PROCESS CHANGE NOTICE
 PRODUCT CHANGE NOTICE

Document Title: Product Change Notice - Notification Only	Document ID: 18-0582/J
---	------------------------

TITLE:
PACKAGE OUTLINE,
8, 12, 16L THIN QFN, 3x3x0.75mm

DOCUMENT CONTROL NO.
21-0136

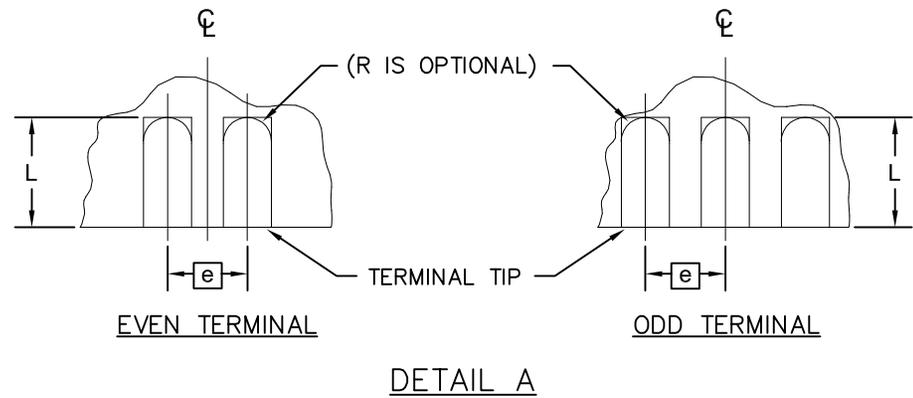
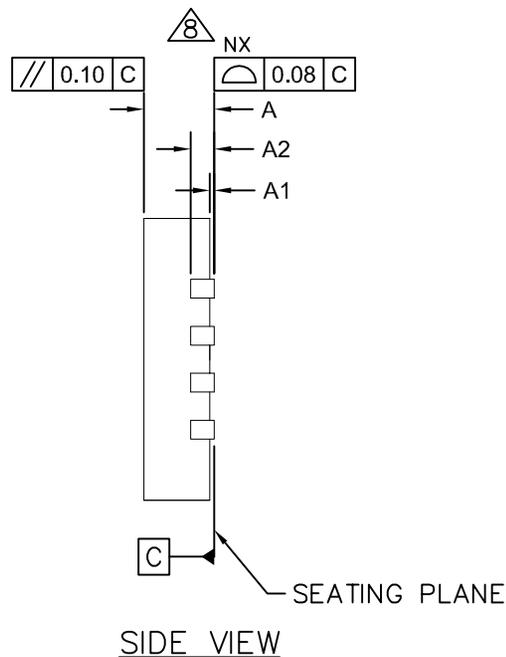
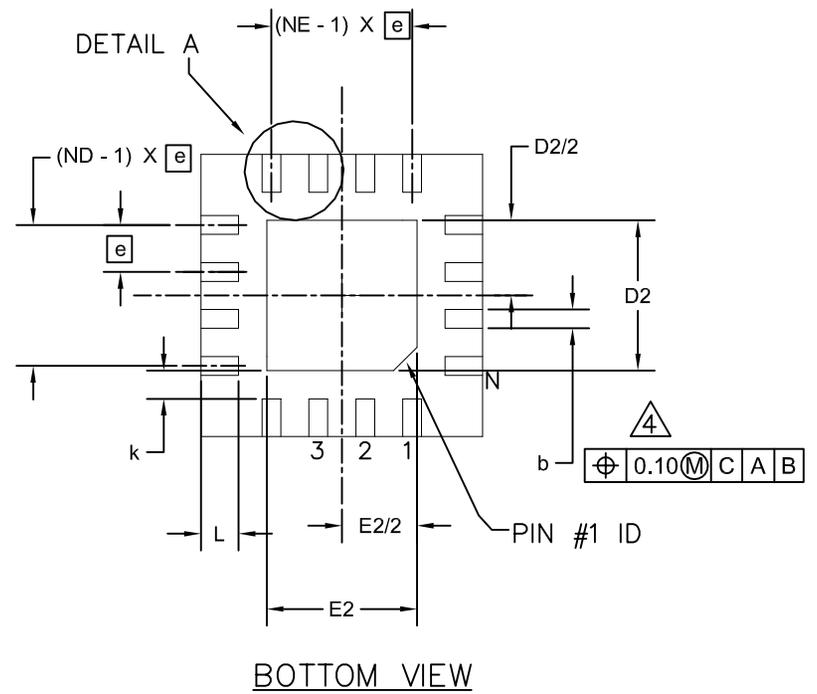
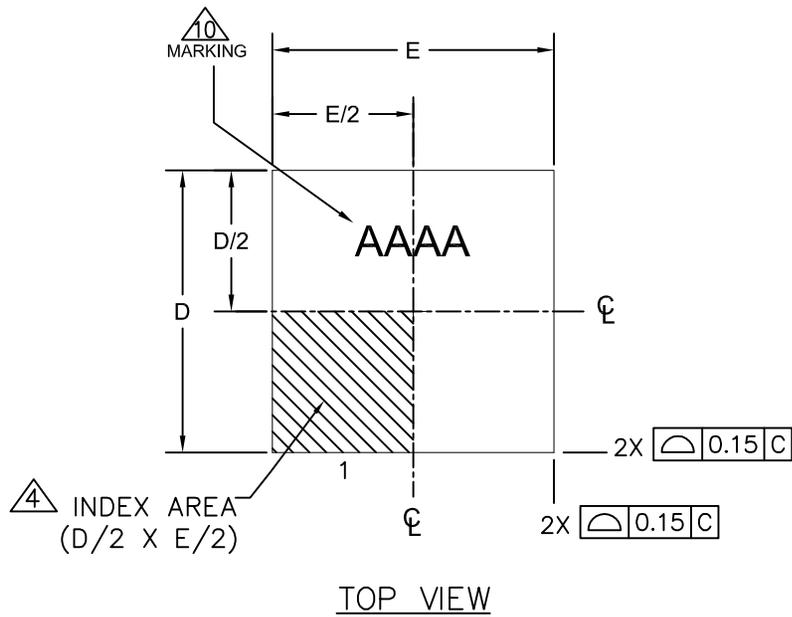
CHANGE FROM: T1233-4: Lead Length (L): Min 0.45mm; Nom 0.55mm; Max 0.65mm T1633-5: Lead Length (L): Min 0.3mm; Nom 0.4mm; Max 0.5mm	CHANGE TO: T1233-4: Lead Length (L): Min 0.35mm; Nom 0.45mm; Max 0.55mm T1633-5: Lead Length (L): Min 0.25mm; Nom 0.35mm; Max 0.45mm
--	---

JUSTIFICATION: Updating the package outline drawing of these package codes T1233-4 and T1633-5 to correct/match the actual lead length that Maxim has been providing to our customers. Please see the attached drawing. This is a drawing correction only for lead length. There has not been any changes to the physical dimensions or manufacturing of the affected devices.
 This is a notification only PCN.

EXPOSED PAD VARIATIONS										
PKG. CODES	D2			E2			L			PIN ID
	MIN.	NOM.	MAX.	MIN.	NOM.	MAX.	MIN.	NOM.	MAX.	
T1233-4	0.95	1.10	1.25	0.95	1.10	1.25	0.35	0.45	0.55	0.35 x 45°
T1633-5	0.95	1.10	1.25	0.95	1.10	1.25	0.25	0.35	0.45	0.35 x 45°
T1633-5C	0.95	1.10	1.25	0.95	1.10	1.25	0.25	0.35	0.45	0.35 x 45°
